Ford Mondeo Model year 2001

Noises from the heating system.

Bulletin

Temperature flap setting motor

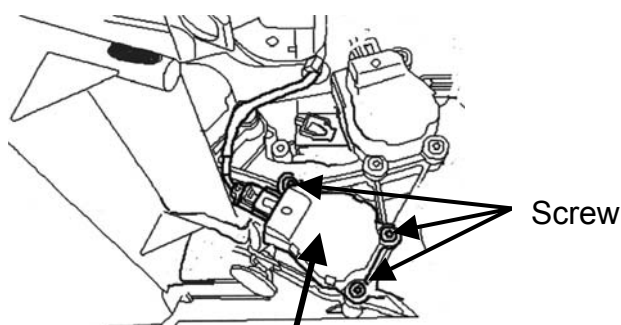
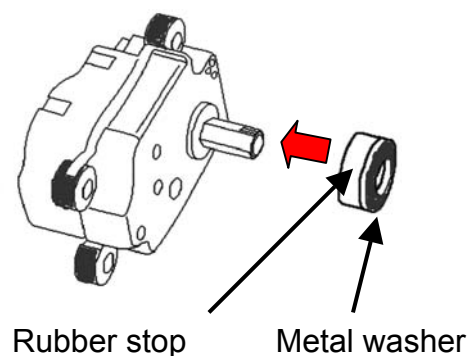
If there are complaints with these vehicles that knocking, clapping noises can be heard from the heating system when the fan is switched to stage 3 or 4, one possible reason is the temperature flap in the heating housing swinging up and down. The high air speed in fan stages 3 and 4 causes the flap to bang against the housing. The problem can be eliminated by installing a rubber stop on the setting motor of the temperature flap. To do this proceed as follows:

- Remove the glove compartment
- Remove the setting motor of the temperature flap, loosen 3 Torx screws and separate the plug-type connections.
- Push the rubber stop onto the setting motor shaft (metal disc facing the temperature flap).
- Replace the components in reverse order.

From 06.2001 a modified temperature flap was used which prevents swinging. The necessary spare parts (rubber stop) must be purchased from Ford.
